Interactive comment on “Time difference of arrival estimation of microseismic signals based on alpha-stable distribution” by Rui-Sheng Jia et al.

Referee #1

Fig. 3.

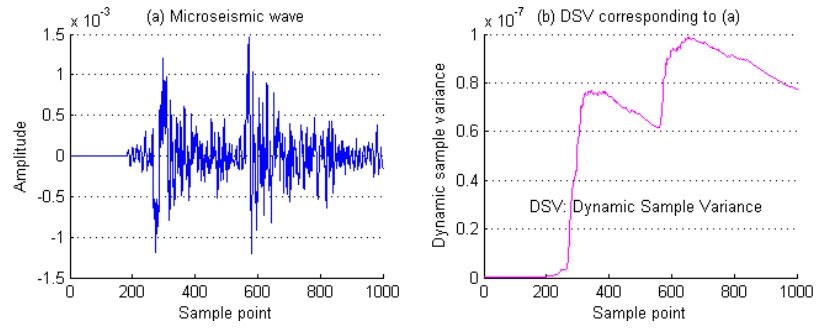
Q5. In Fig3(a), the energy of P wave is larger than the energy of S wave. But in most field microseismic data, the energy of S wave is larger than the energy of P wave, so I think your measured microseismic signal is not representative.

A5: It is really true as Reviewer suggested that our measured microseismic signal is not representative, We have chosed a typical microseismic signal and redrew Fig. 3. For more detail , see Fig. 3 in P17.

Fig. 6.

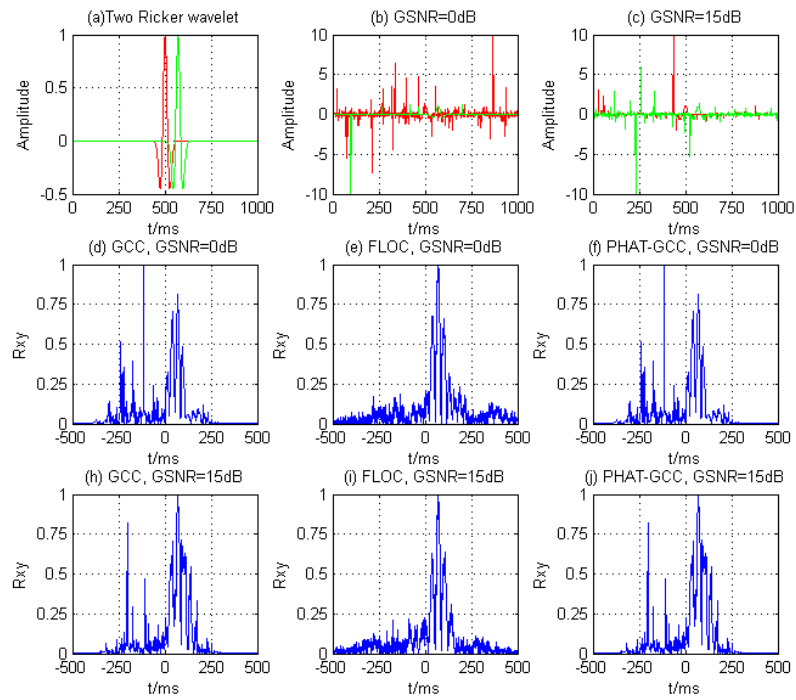
Q6. In Fig. 6, your method is just compared with one conventional method. I think this is not enough, your method should be compared with two conventional methods at least so that the advantages of your method are more persuasive.

A6: Considering the Reviewer's suggestion, we have added PHAT-GCC method to be compared. See P18.
